Access Compliance Report

Public Rights-of-Way

(Curb Ramps)

Intersection ID: 12268	Main Street: BELLE_TERRE_AV	Cross Street: THE_PLAZA	Location: W
ADA ID: 8C132EF1E2A3	Ramp Type: BlendTrans1	Initial Pass/Fail: Fail	Overall Compliance: No
Severity Score: 1.25			
Codes/Mitigation Info/Possible Solution		Field Measurements/Component Compliance

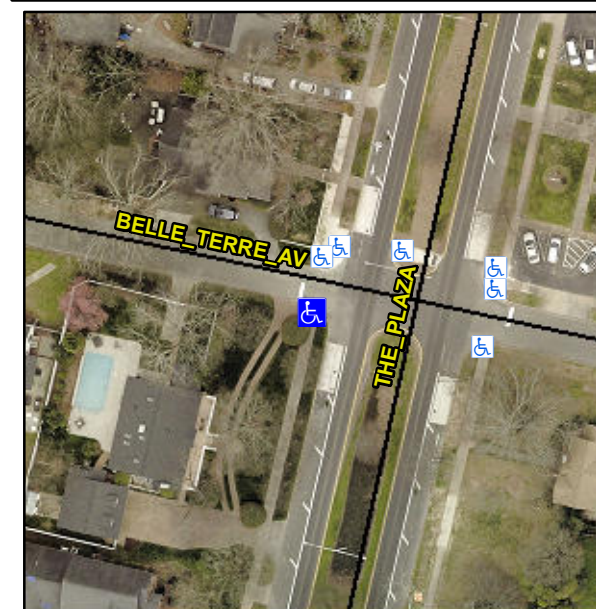
R304.5.3

Compliance	Description	Data	Compliance	Description	Data
N/A	Ramp Length (in)	51.0	Yes	BlendTrans Slope (%)	3.3
Yes	Ramp Width (in)	67.5	No	BlendTrans XSlope (%)	4.0
N/A	Flare Type LT	N/A	N/A	Flare Type RT	N/A
N/A	Flare Slope LT (%)	N/A	N/A	Flare Slope RT (%)	N/A
N/A	Flare Traversable LT?	N/A	N/A	Flare Traversable RT?	N/A
N/A	Landing Length (in)	N/A	N/A	DWS Provided?	N/A
N/A	Landing Width (in)	N/A	N/A	DWS Contrast?	N/A
N/A	Landing Slope (%)	N/A	N/A	DWS Length (in)	N/A
N/A	Landing X Slope (%)	N/A	N/A	DWS Full Width?	N/A
N/A	Landing Curb? (Y/N)	N/A	N/A	DWS Offset (in)	N/A
N/A	Shared Landing?	N/A			
N/A	Gutter Ponding?	N/A	N/A	Gutter Slope (%)	N/A
N/A	Gutter Lip Ht (in)	2.0	N/A	Gutter X Slope (%)	N/A
N/A	Painted X Walk1?	No	N/A	Painted X Walk2?	N/A
	X Walk 1 Direction	To N		X Walk 2 Direction	N/A
	X Walk 1 Width (in)	N/A		X Walk 2 Width (in)	N/A
	X Walk 1 Slope (%)	1.9		X Walk 2 Slope (%)	N/A
	X Walk 1 X Slope (%)	0.2		X Walk 2 X Slope (%)	N/A

Remove & Replace Curb Ramp With Two New Directional Ramps or Equivalent.
